SERVICE BULLETIN #126

Date: 7-25-90

This service bulletin applies to all Aerostar hot air balloons which are equipped with AFT 2-Point suspension cables.

Diagram One

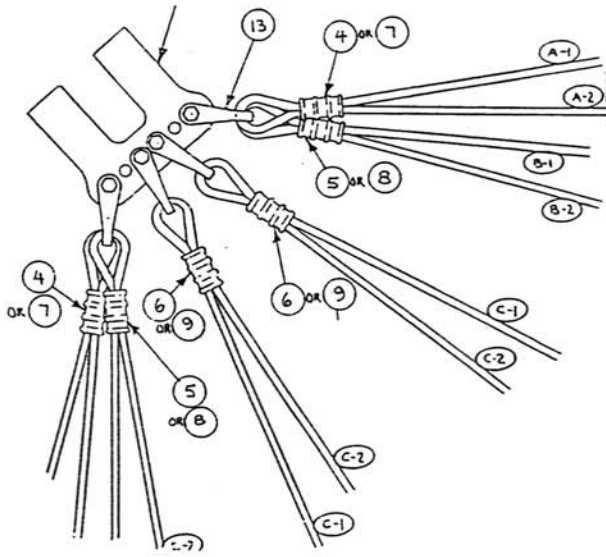
This service bulletin is issued to address service difficulties experienced with 2-Point AFT cable systems. All current 2-Point AFT systems utilize cable attachment to the suspension fitting as shown in Diagram 1. The difficulty with the fitting is that the cables may twist around the shackle and "pop" the cable thimble out of the cable loop, exposing the cable to the sharp edges of the shackle. This condition is addressed in Service Bulletin #124 and in part in #125.

This operation must be performed by a repair station, and must be performed on or before the next annual/100 hour inspection. The suspension block and shackle assemblies as shown in Diagram 1 must be replaced with assemblies as shown in Diagram 2 (a), (b), or (c), for 16 gore, 20 gore, or 24 gore balloons respectively.

Diagram Two (a), 16 gore

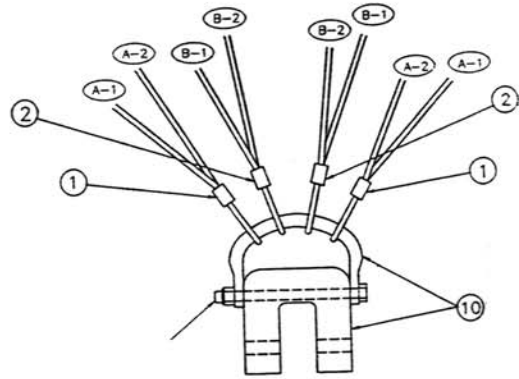
Each cable-pair assembly must be removed from its shackle and installed on the single shackle (in the order as shown on the respective diagram 2 (a), (b), or (c).) For locations of cable pair designators, (A-1, A-2, B-2, etc.) for respective cable sets, refer to Aerostar Instructions For Continued Airworthiness, Appendix J., Revision G. The grade-8 bolt is then installed through the shackle and suspension fitting as shown in the diagram, then torqued to 45-50 in-lbs. with alignment of the shackle with the suspension fitting as shown in diagram 3.
